Technical Service Bulletin-ATTENTION SERVICE MANAGER

Machine Name: Carpetriever 28, GU 700A / Champion 28 / DuraTrac 19 /, Servicemaster Wide Area Tri Vac

ECO#: A-01335

Subject: New wheels to be used on the above machines.

Carpetriever 28
GU 700A
Champion 28
Wide Area TriVac

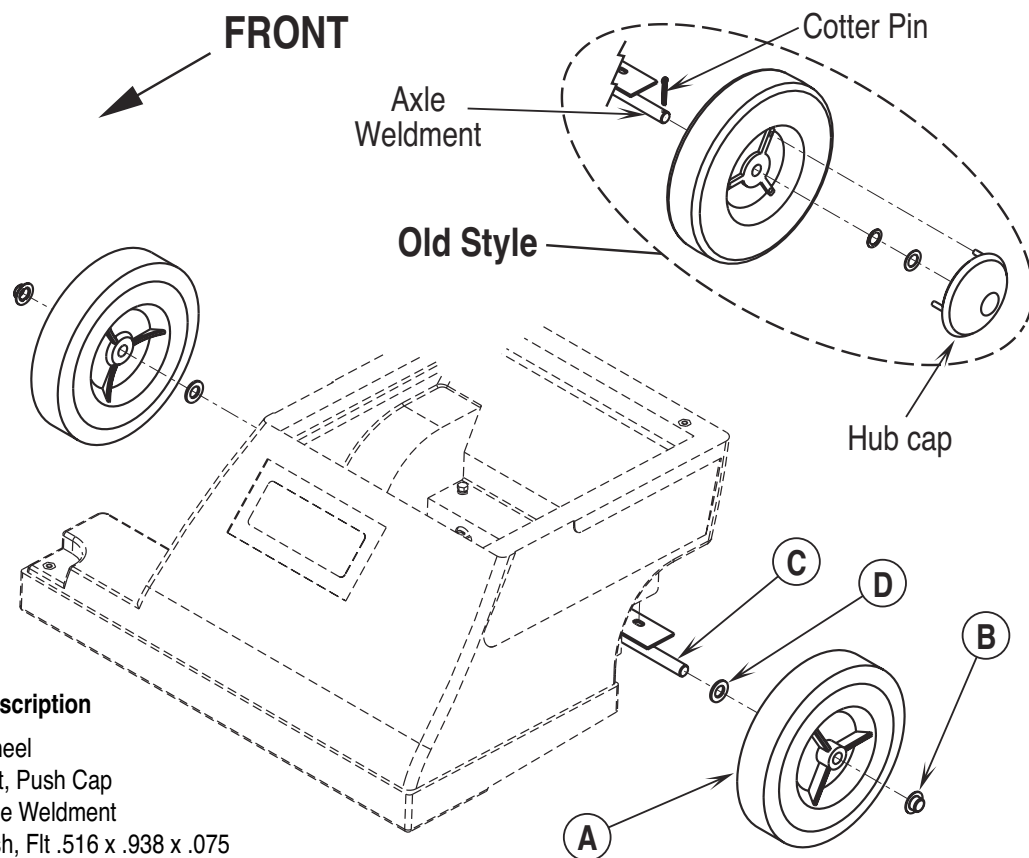
• All models except DuraTrac 19: This ECO changes the wheel and the axle. The hubcaps are being removed and the fasteners are changing from cotter pins to push-on caps. If replacing wheels on machines before the serial number break it is necessary to purchase the following: two wheels (PN 56210148), one axle weldment (PN 56330045), two push-on nuts (PN 56009097) and two washers (PN 56009003).

DuraTrac 19 only

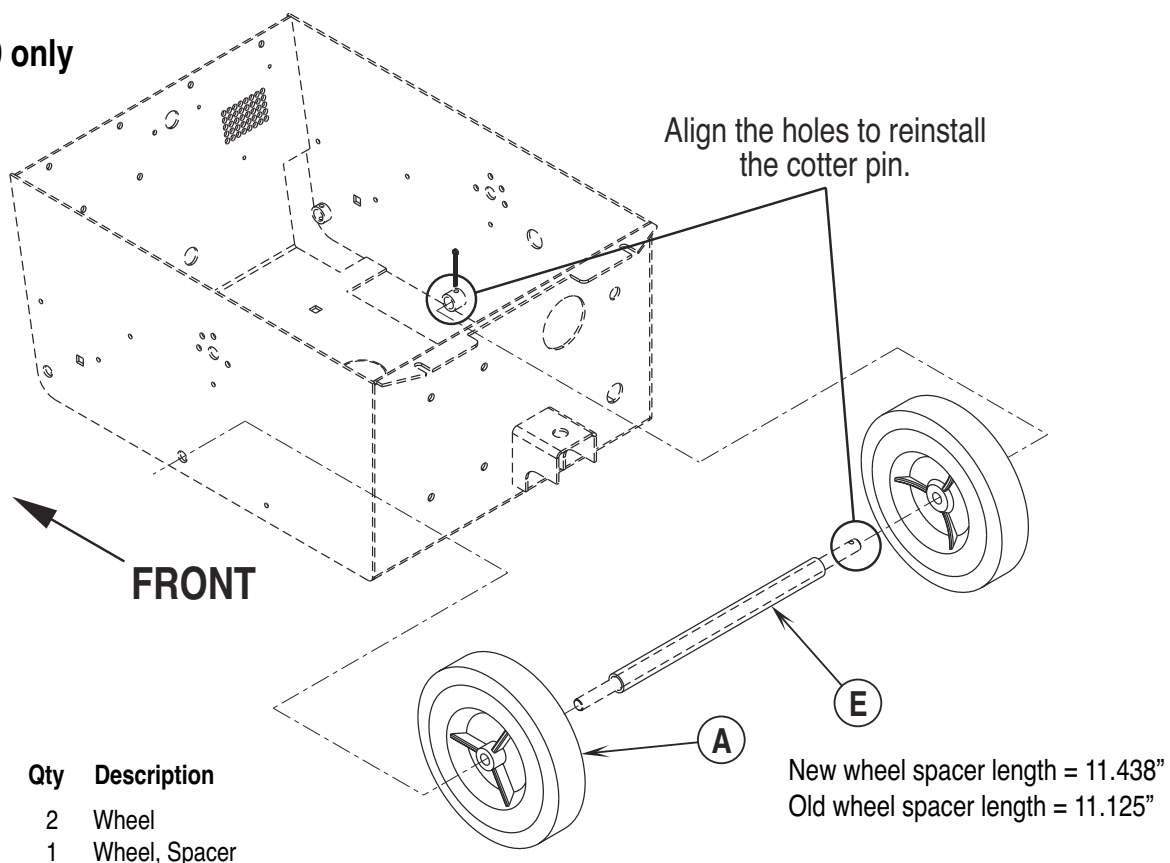
• DuraTrac 19 only: This ECO changes the wheel and the spacer, which goes between the wheels. If replacement wheels are needed on machines before the change, it is necessary to purchase one wheel spacer (PN 56330047), which slides over the axle, for proper wheel spacing.
